DePinho Roofing
742 East Main Street
Orange, Ca. 92865

GATE/FENCE SITE PLAN DATE: 05/22/2025

GATE/FENCE

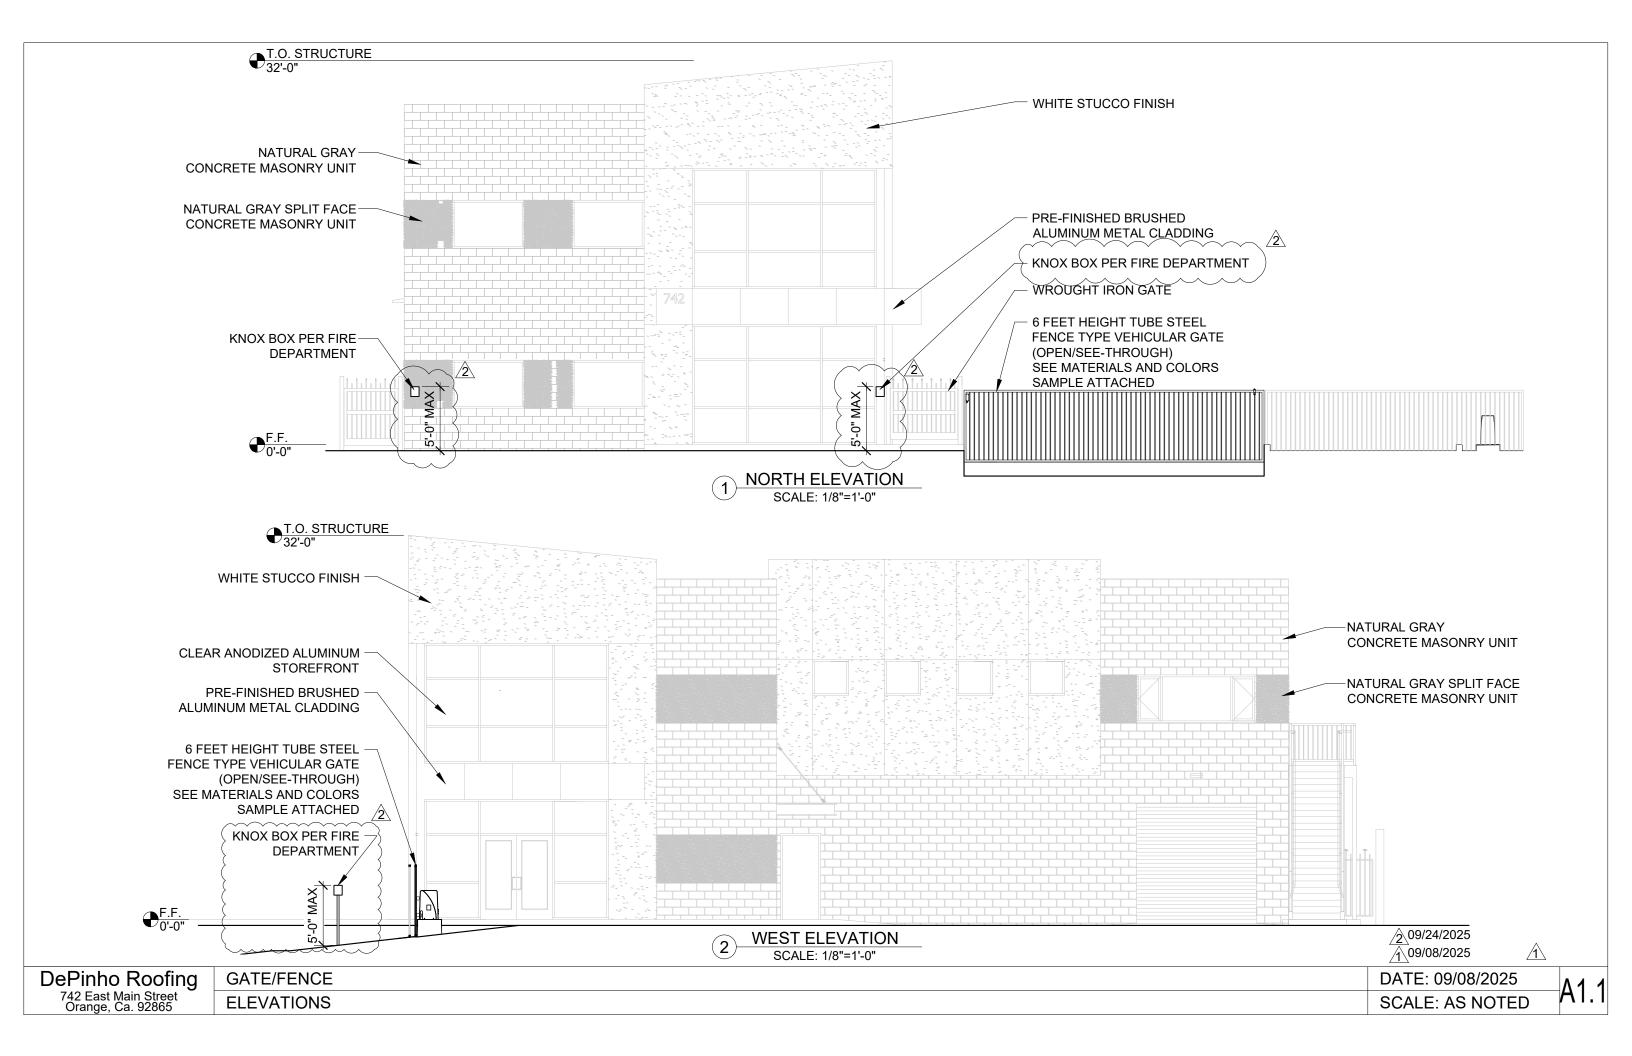
PLANNING DIVISION CORRECTION NOTES:

1. KEY BOXES AND KEY SWITCHES (KNOX DEVICES) SHALL BE PROVIDED WHERE NECESSARY TO ENSURE THAT IMMEDIATE ACCESS FOR FIREFIGHTING, RESCUE AND OTHER EMERGENCY PURPOSES IS POSSIBLE. KNOX BOX TO BE SUB-MASTERED FOR POLICE ACCESS.

- 2. AT LEAST ONE PEDESTRIAN GATE WITH UNRESTRICTED LEVER OR PANIC HARDWARE IS REQUIRED ON PERIMETER GATES.
- 3. ELECTRIC GATES SHALL COMPLY WITH THE REQUIREMENTS OF AN AUTOMATIC OPENING DEVICE IN COMPLIANCE WITH UL 325 AND ASTM F-2200 IN ADDITION TO THE KEY OPENING DEVICE.
- 4. THE APPLICANT SHALL COORDINATE WITH THE CITY'S SOLID WASTE PROVIDER TO ENSURE SERVICE ACCESS.
